14/03502/FULL1 | Demolition of existing dwelling and erection of 2 two storey buildings with accommodation within the roofspace comprising 8 two bedroom flats with landscaping, two new vehicular accesses and 12 parking spaces. | 61 The Avenue Beckenham BR3 5EE

Ravensbourne Valley Preservation Society

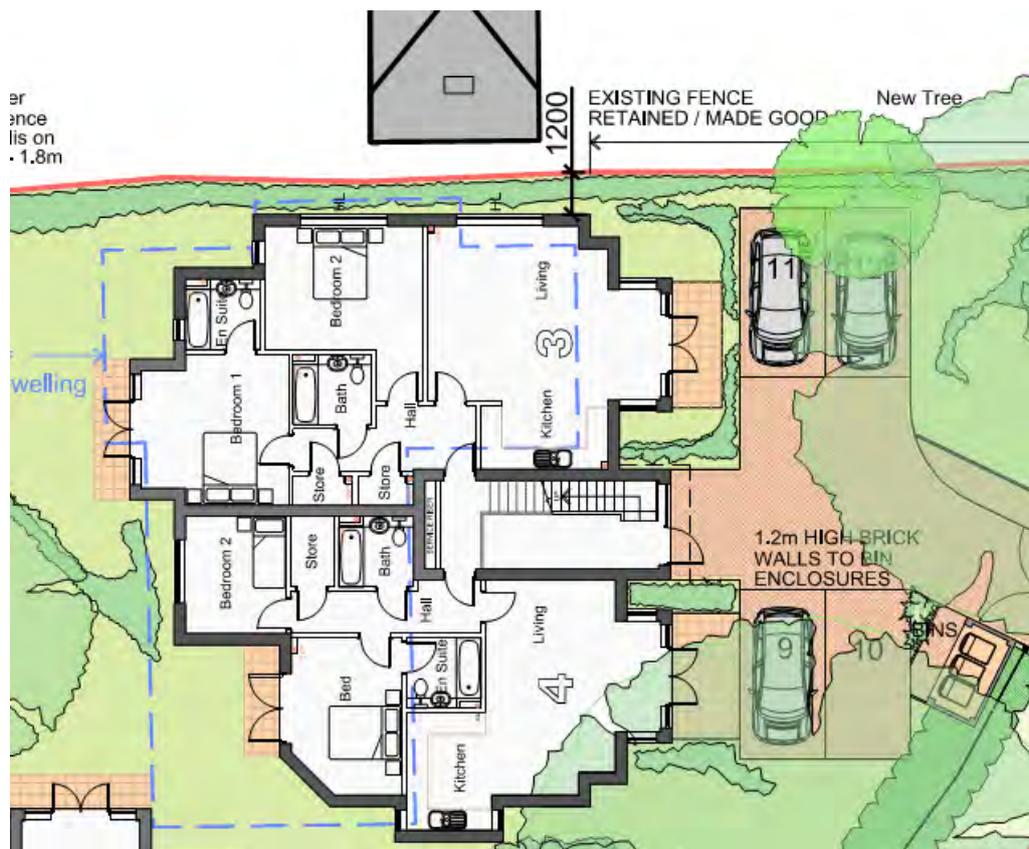
The footprint of the north block is significantly larger than the existing property and also extends some way beyond the existing front building line for this site. Further, the west block does not respect the rear building line which was specifically requested in the pre-application advice letter which stated ‘... the front and rear building lines should be respected.’

We have in our possession a dimensioned and annotated version of the document called ‘The Proposed Site Plan’ which we attach for your convenience at Appendix 1. Amongst other things, we notice that the proposed side space of the north block is only 1.2 metres whereas the pre-application advice letter requires 2 metres: -

This self-evidently misrepresents the position shown in the diagram below: -

Further, overhanging guttering etc. would mean that this 1.2 metres would be further reduced and would not extend for the full height and length of the flank elevation.
